25-Apr-2025 - Redlines - DD

Lot 51 - Duncans Creek

PLAN 1  
The Clayton - RH

'LOW COUNTRY'  
ELEVATION

Cover Sheet 'Low Country'

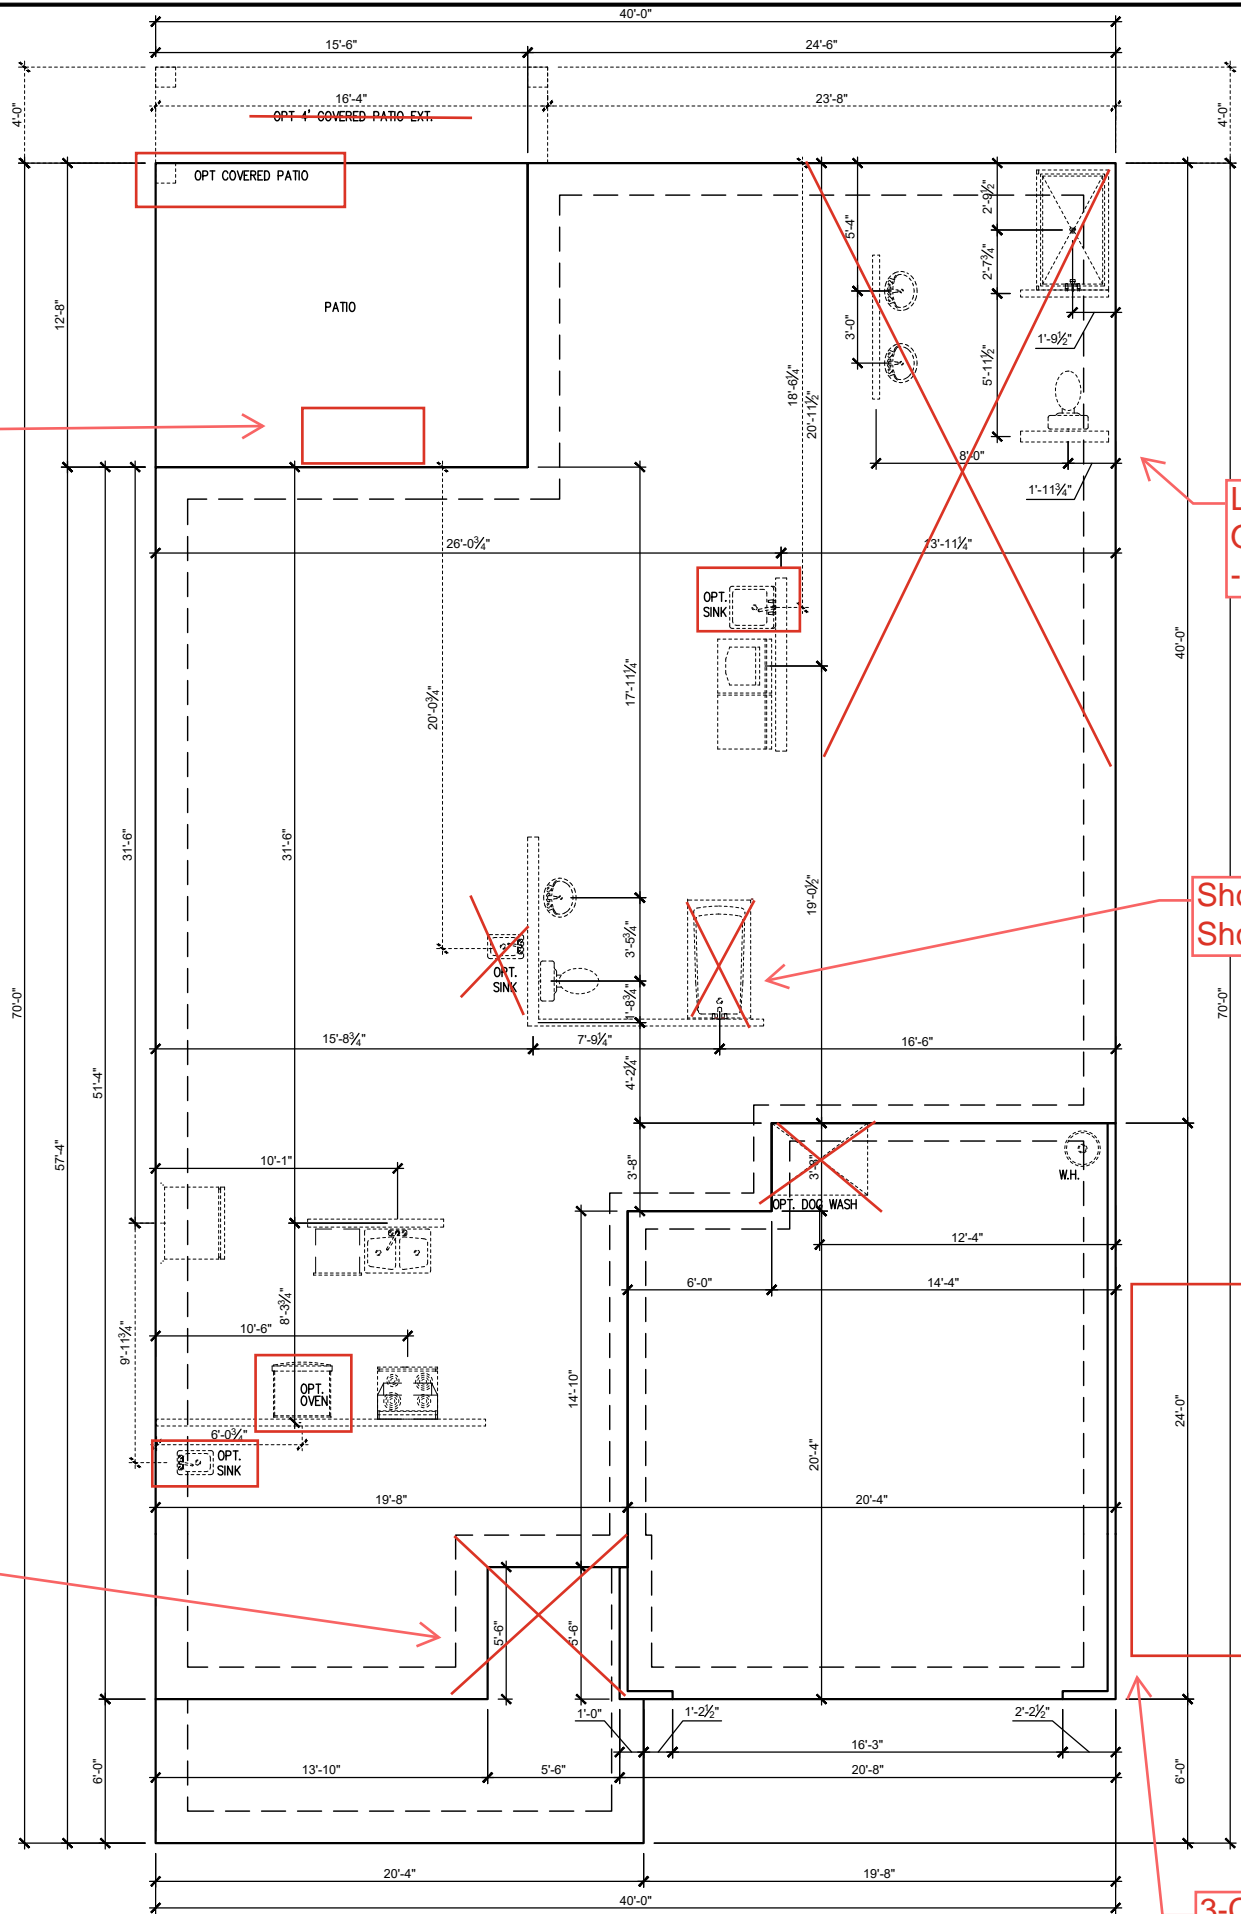
Fireplace @  
Covered Porch -  
1.1.1a

Smart Door  
Delivery - 1.1.1a

Large W.I.C. w/  
Opt. Super Shower  
- See Bottom Left

Shower ILO Tub/  
Shower

3-Car Garage -  
1.1.1a

FIRST FLOOR PLAN 'LOW COUNTRY'

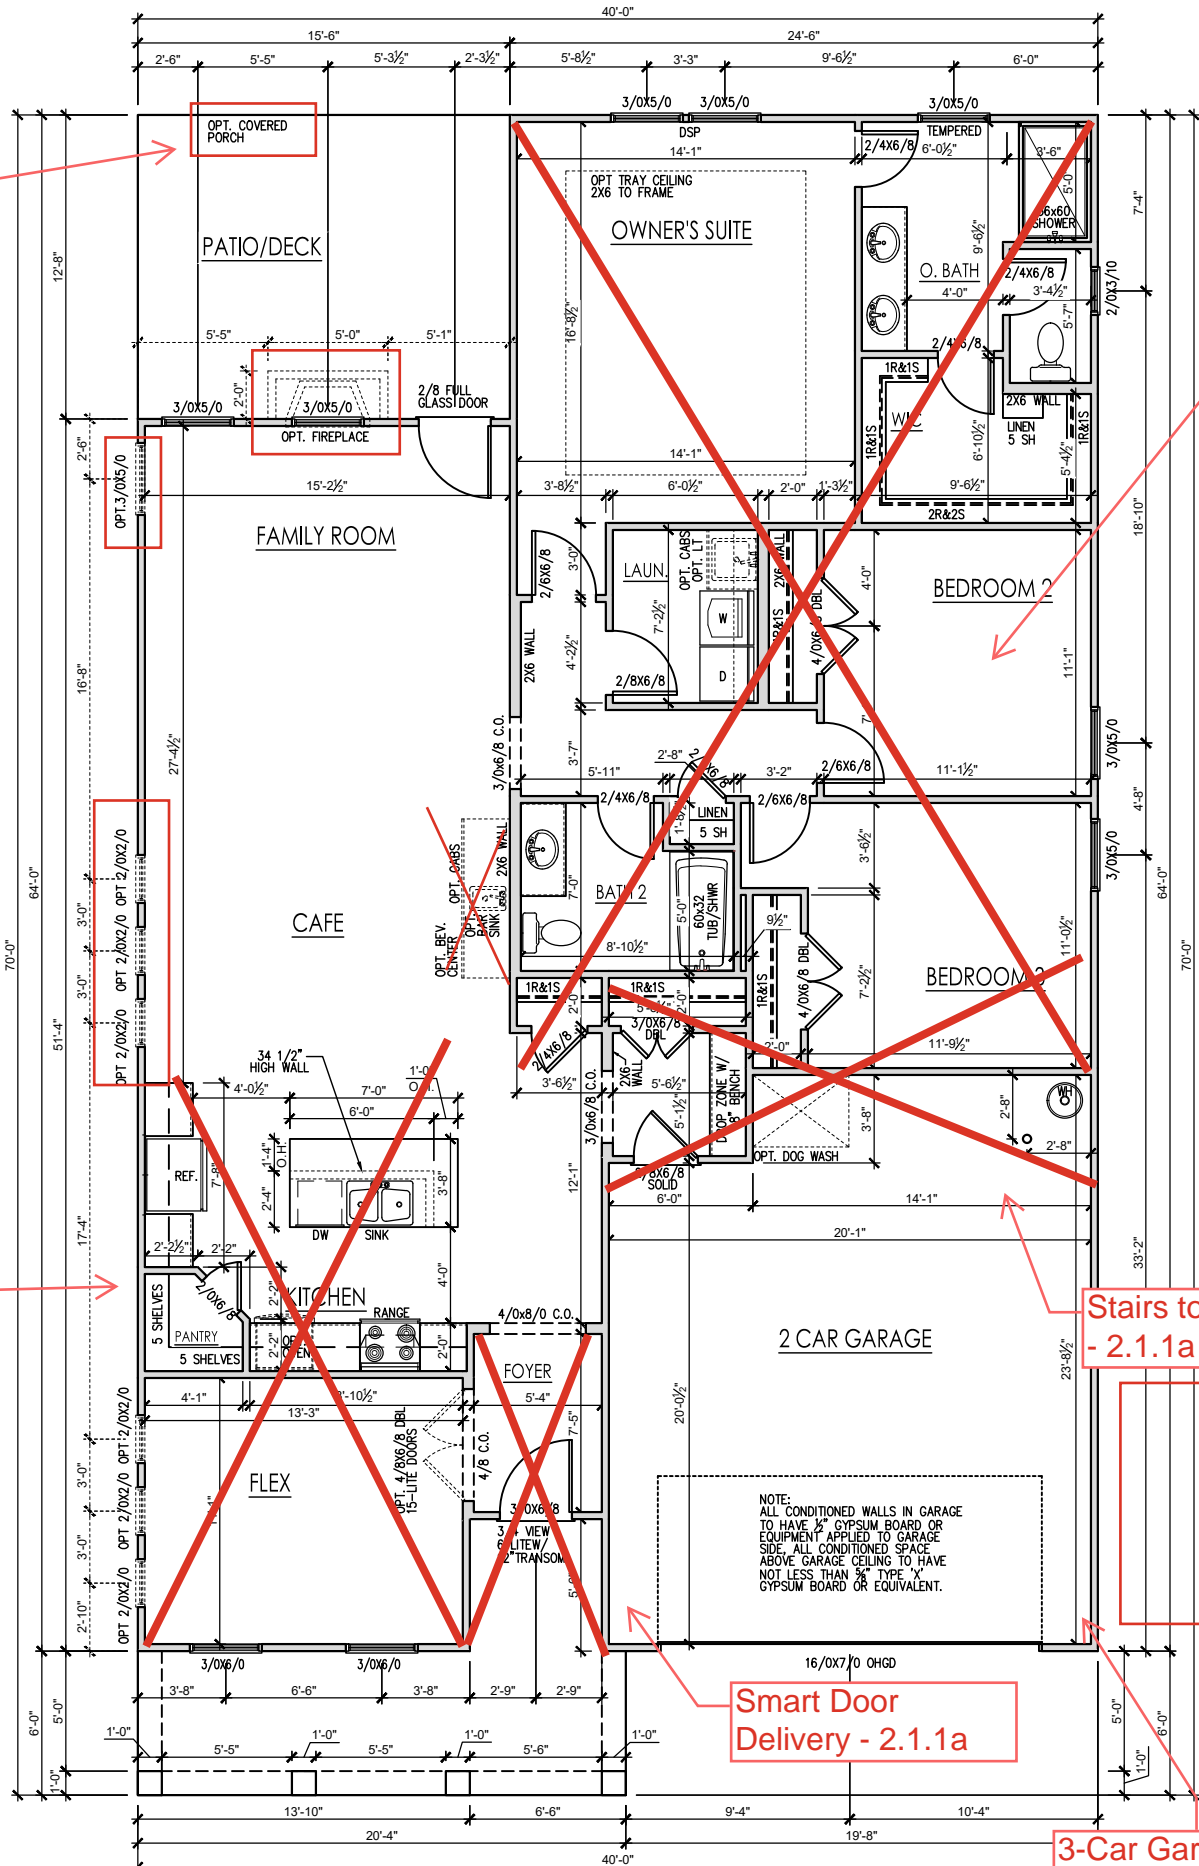
Covered Porch - 2.4a

Owner's Suite w/ Large W.I.C - 2.1.2a

Messy Kitchen & Pocket Office - 2.1.1a

Stairs to 2nd Floor - 2.1.1a

Smart Door Delivery - 2.1.1a

3-Car Garage - 2.1.3a

OPT. SECOND FLOOR PLAN 'LOW COUNTRY'

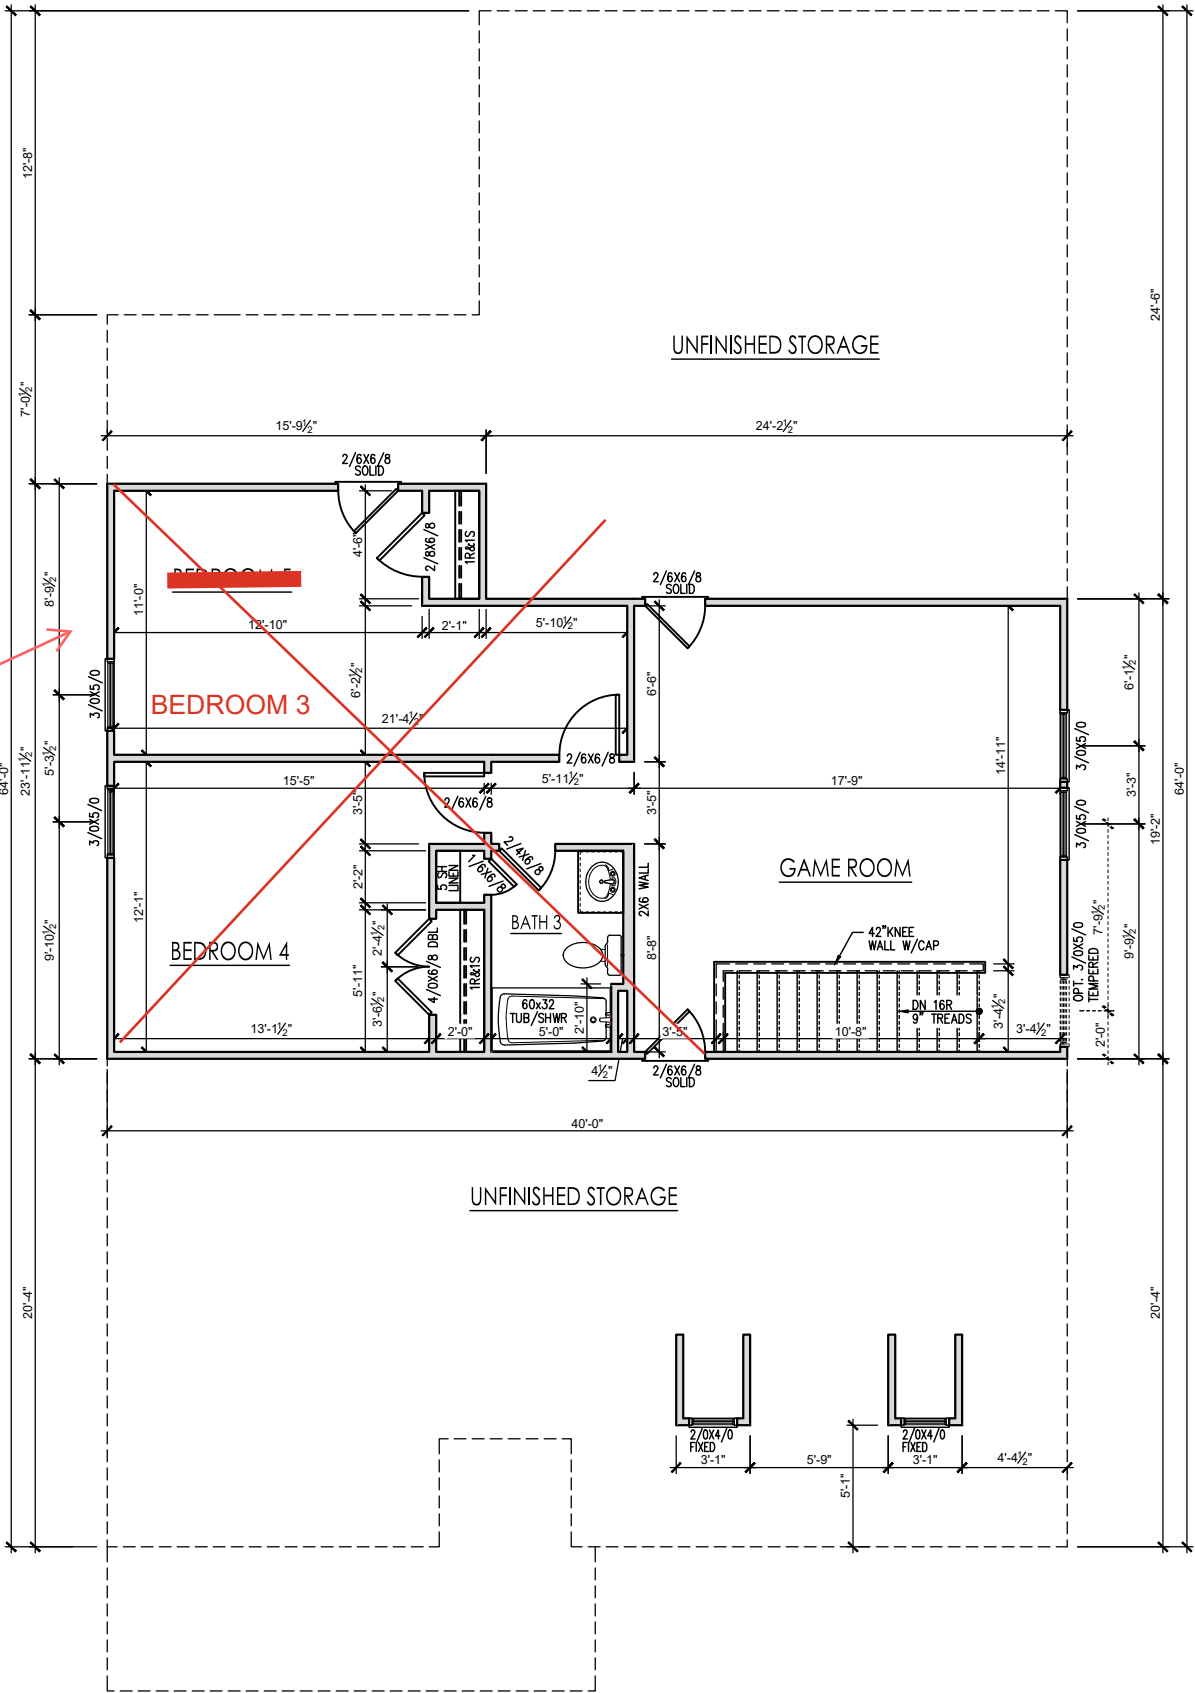
Pocket Office -  
2.2.1a

THE CLAYTON - RH  
---  
Front & Rear Elevations (Slab) 'Low Country'

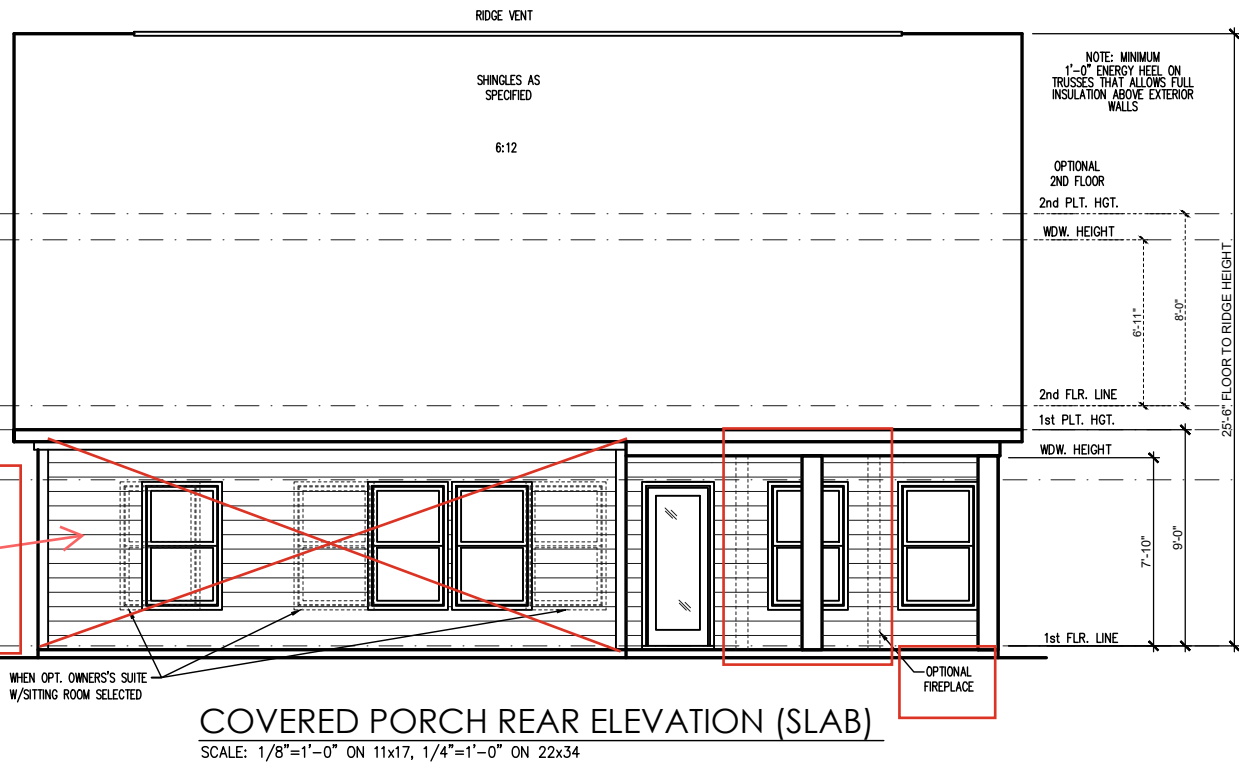
Fireplace - 2.1.1a

Windows Change  
w/ Large W.I.C.

3-Car Garage -  
3.3.2a

FRONT ELEVATION 'LOW COUNTRY' (SLAB)

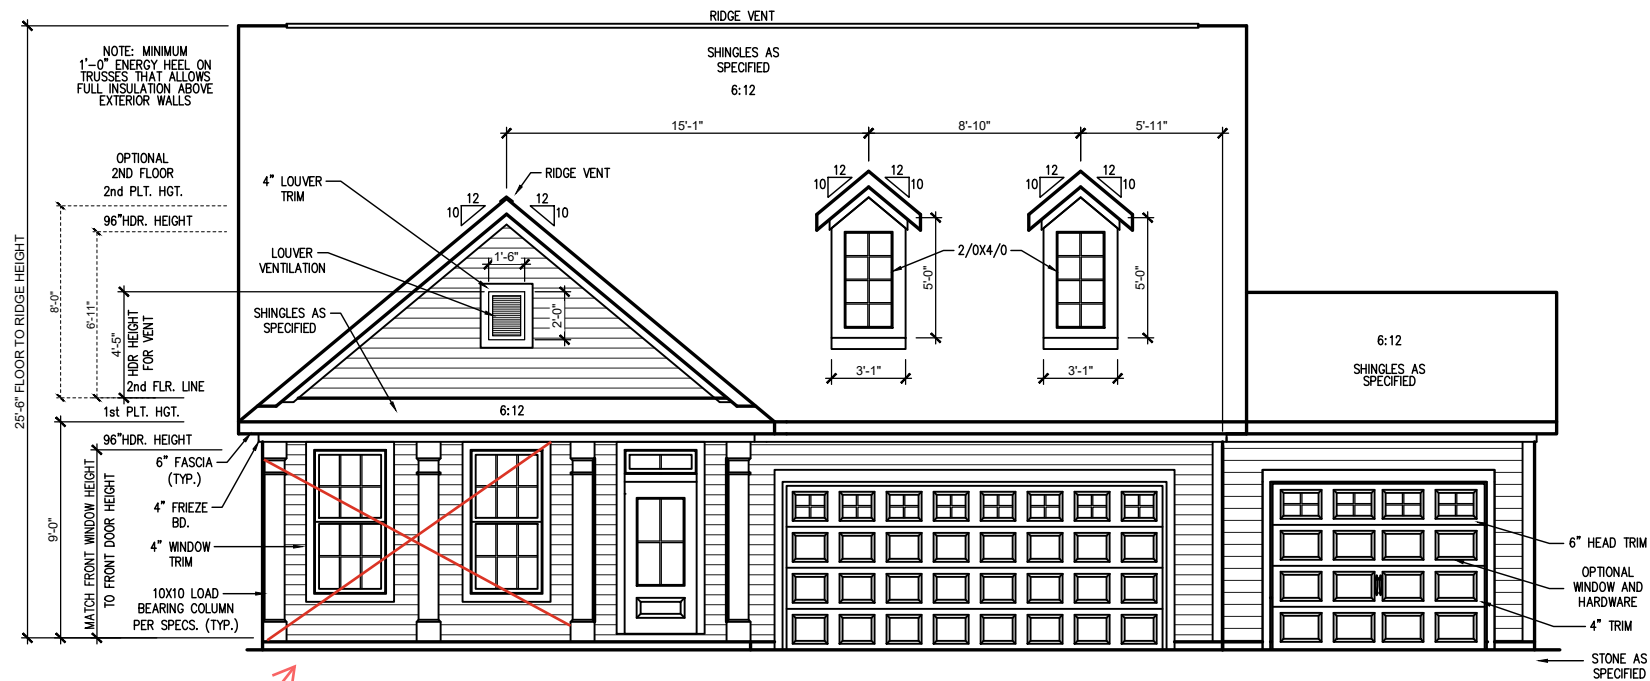
Covered Porch  
Elevation - 2.4a

Window Locations  
- 3.1a

## WITH SECOND FLOOR FIRST FLOOR PLAN 'LOW COUNTRY'

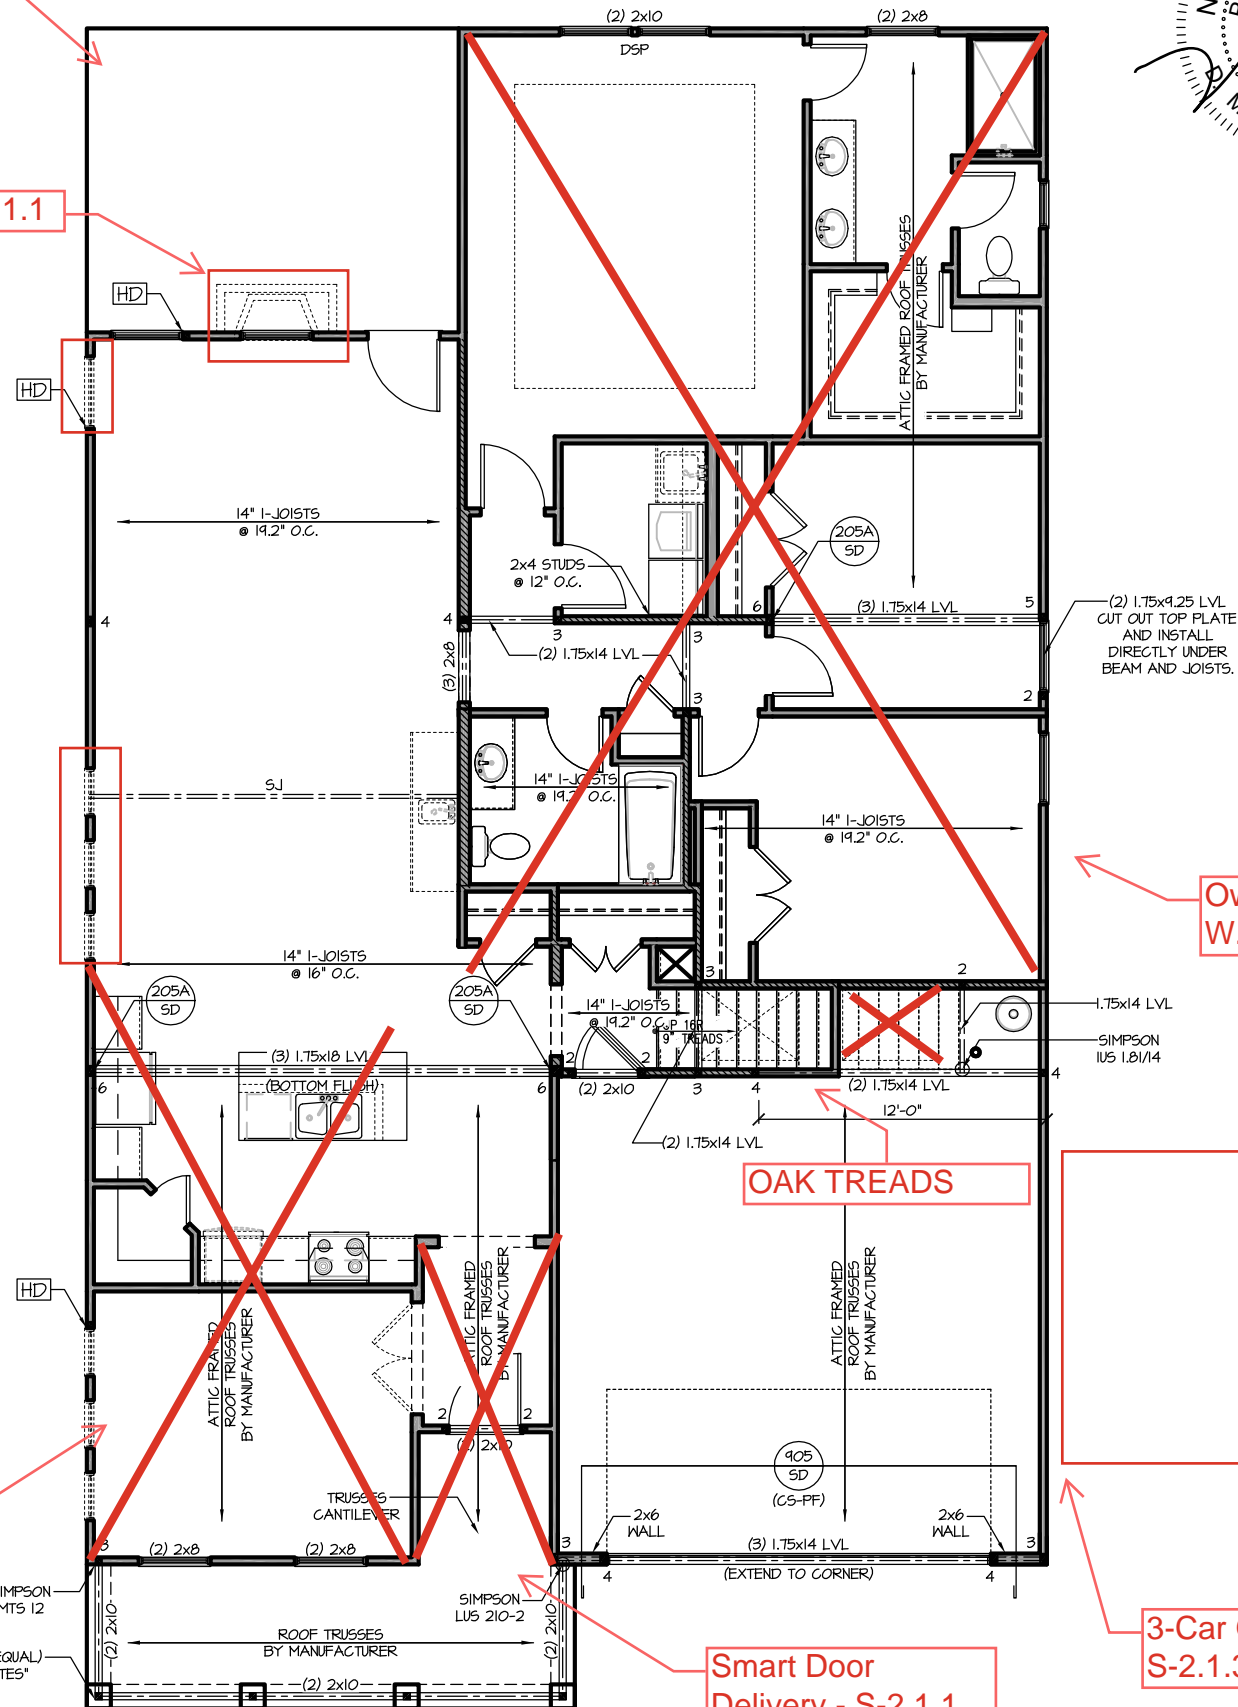
Covered Porch -  
S-2.3

Fireplace - S-2.1.1
